## **HOLDOVER**

### **TIMBERLANE WOODS SUBDIVISION, UNIT ONE**

### ***Revised for the December 1<sup>st</sup> meeting:***

# TIMBERLANE WOODS SUBDIVISION

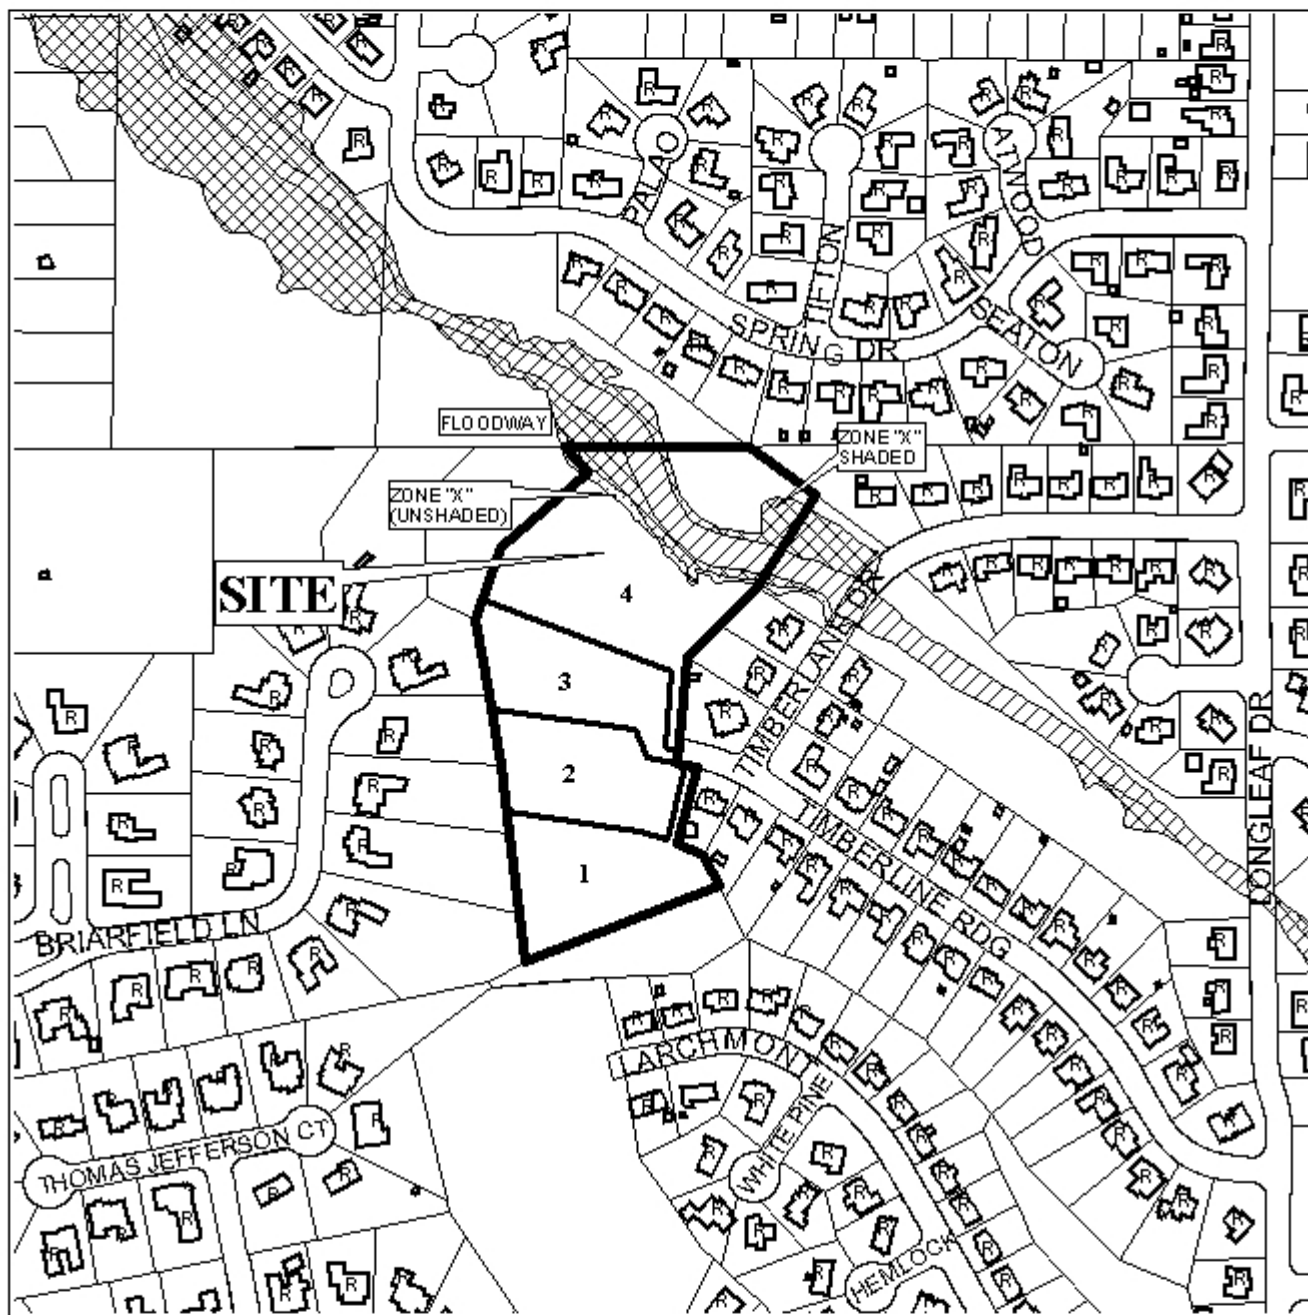
The 25-foot minimum building setback lines are not shown but would be required on the final plat.

As indicated on the plat, the site shows two of the lots as flag-shaped, which exceeds the depth to width ratio recommended in Section V.D.3. of the Subdivision Regulations. Furthermore, the flag-shaped nature of the proposed lots is uncharacteristic of other properties in the area and thus not in conformance with Section V.D.1. of the Subdivision Regulations. Additionally, in January 2005, the Commission approved this site for 33 lots with a modified turnaround/cul de sac.

Based on the preceding, the application is recommended for Holdover until the December 1<sup>st</sup> meeting to allow the applicant time to submit a revised plat showing no flag-shaped lots and a modified turnaround/cul de sac.
